Permit # _____ City of _____ BUILDING PERMIT APPLICATION Fee _____ Zone _____ Map # _____ Lot# _____

Explain Conversion Install 15,000 Gal above grnd oil tank

Re: Rand Rd

Your application to install a 15,000 gallon above ground tank has been reviewed and a permit is herewith issued subject to the following requirements:

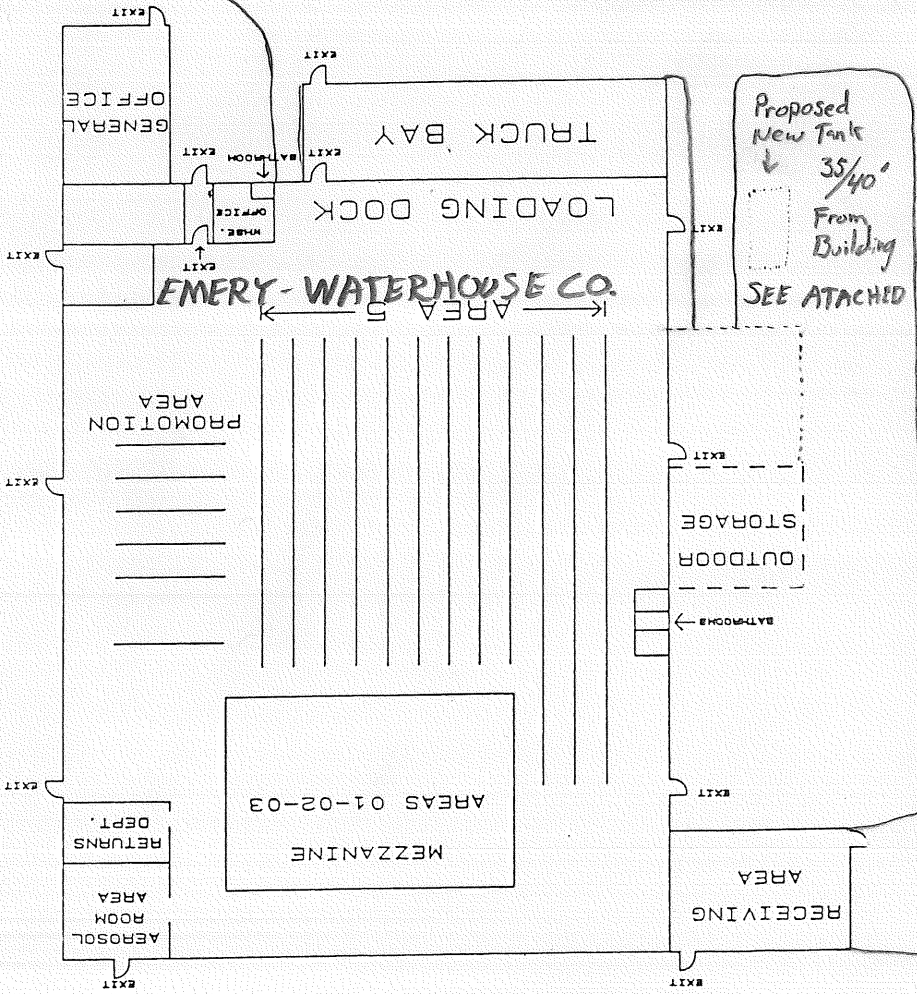
1. A travel lane at least 16' wide shall be maintained between the tanks installation and the building.
2. Piping shall be installed in such a way that it is protected against mechanical damage by vehicles in the area.
3. Installation shall be done in accordance with Section 2-3 of N.F.P.A. #30.
